MAY 1981

**NAME OF DAM:** COLD SULPHUR SPRINGS  
**LOCATION:** ROCKBRIDGE COUNTY, VIRGINIA  
**INVENTORY NUMBER:** VA 16307

**PHASE I INSPECTION REPORT  
NATIONAL DAM SAFETY PROGRAM**

COLD SULPHUR SPRINGS DAM  
ROCK BRIDGE COUNTY  
27 MAY 1981  
NORFOLK DISTRICT CORPS  
OF ENGINEERS  
PLATE 3

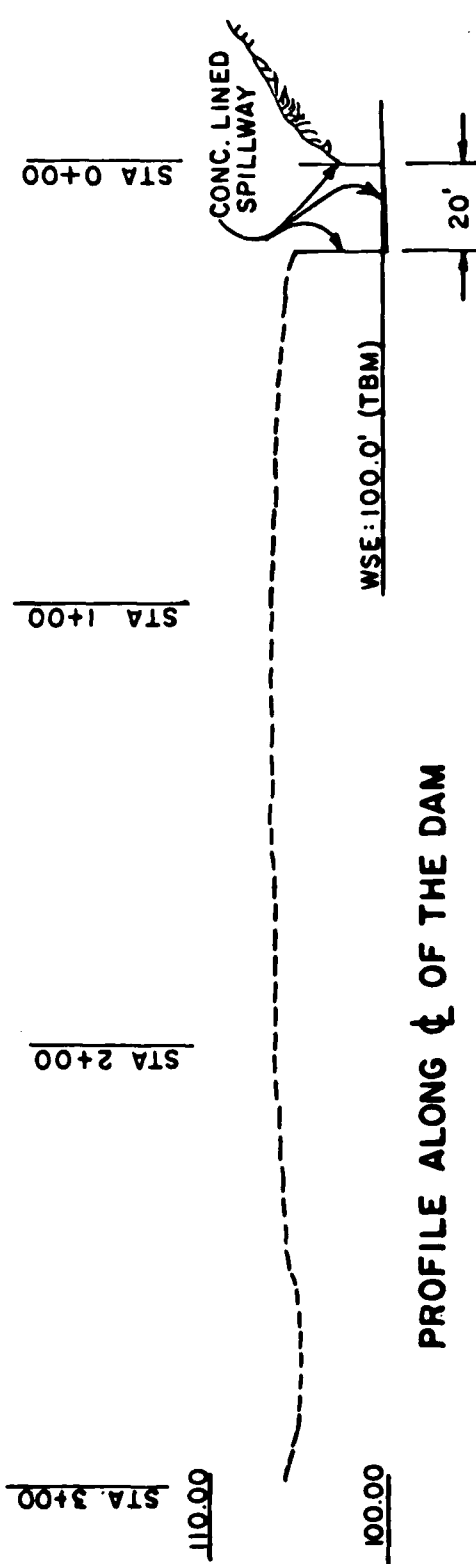
**3.1.4 Drawdown Outlet Works:** The intake structure is submerged and not observable. The drawdown gate valve is located at the downstream toe at about station 1+00 as shown on Plate 3. The 20-inch gas line pipe appears to be in satisfactory condition.
